Document Type: Schematic Review

Customer Name: Schneider

TI Product No: CC2340R5 5x5

JIRA Ticket: SLWIFIHWAPPS-672

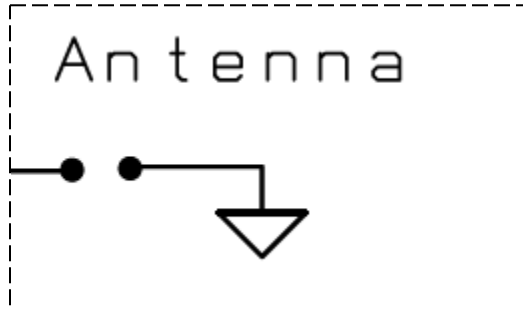
- **Decoupling**
 - Decoupling is insufficient as compared to TI reference design. Reference design uses 1 0.1 μ F per VDDS pin and 1 10 μ F on pin 31
- **32 kHz Crystal**
 - Verify that system meets requirements when running with the lower accuracy LFOSC (No XTAL). See <https://www.ti.com/lit/an/swra499c/swra499c.pdf> for ideas on what to consider
- **48 MHz Crystal**
 - According to the BOM description the crystal does not meet the requirements for BLE (+/- 10%?, I'm not even sure that can be correct) or for load capacitance 10pF exceeds the datasheet specification where the maximum is 9pF. Please review and verify specifications are met.

- RF Path
 - D1 is only needed in the case an external connector is used.
 - L5 will be removed from the next revision of the TI reference design, Rev A
 - Do not recommend jumper in RF path as it will affect impedance:

- If CN3 is used then a DC blocking cap should be included in the path to CN3. In addition C9 should be removed so that both the PCB antenna and external connector for antenna are not in use at the same time.
